# 1969 Corvette: Service News: Delcotron Battery Terminal Contacting Rocker Cover

**Model and Year:** 1969 Corvette with 427 Cu. In. Engine and Power Steering (SN-69-6)

**Source:** Chevrolet Service News

**Date:** January 1969 - Volume 41 - Number 1

**Fig. 1—Corvette Delcotron End Frame Position**

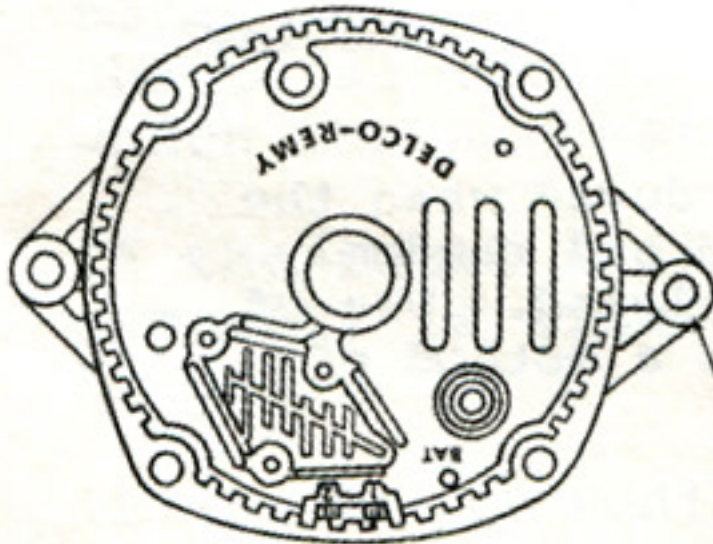
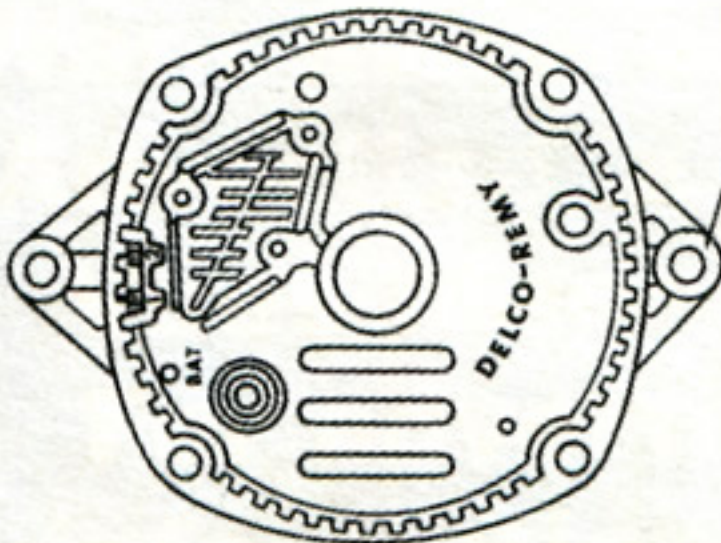
It has been found that it is possible for the battery ("BAT") terminal on the Delcotron to contact the left side rocker cover on some early production 1969 Corvettes equipped with a 427 cu. in. engine and power steering. If this occurs, an electrical short can result.

Production has recently begun changing the position of the end frame to provide increased clearance between the "BAT" terminal and the rocker cover. If a contact situation is encountered, rotate the end frame 90° as shown in Figure 1.
